ENDL TEXAS

Date: 14 June 2008
 To: SNIA OSD TWG and T10 Technical Committee
 From: Ralph O. Weber
 Subject: OSD-2 CDB Continuations Definition and Usage

Figure 4 — OSD security model transactions

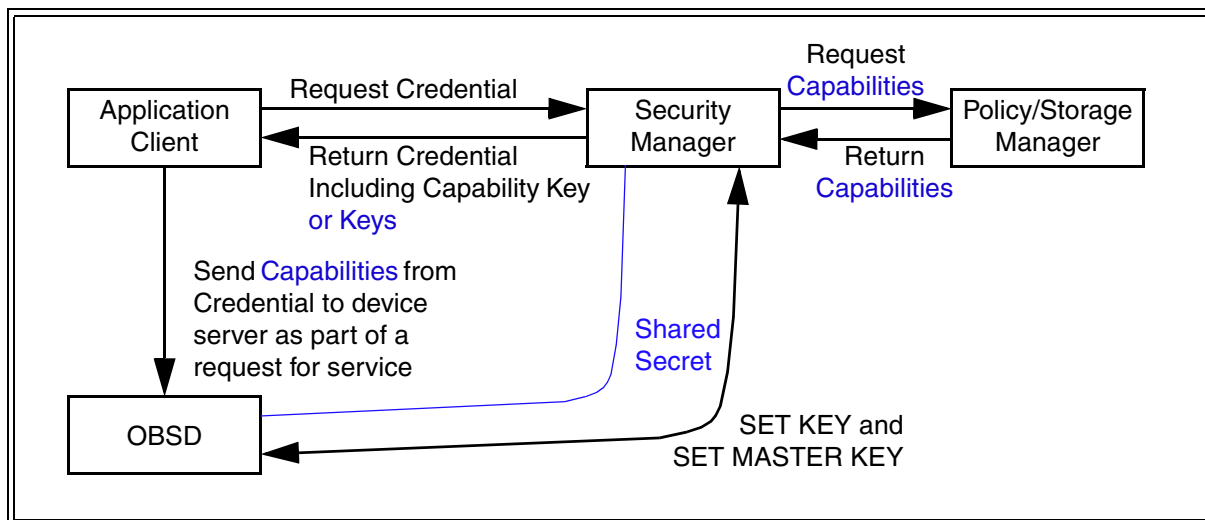
{{With the exception of 'Shared Secret', all the blue text in figure 4 is a replacement for existing text. To keep figure 4 manageable, strikeouts are not show for the old text.}}
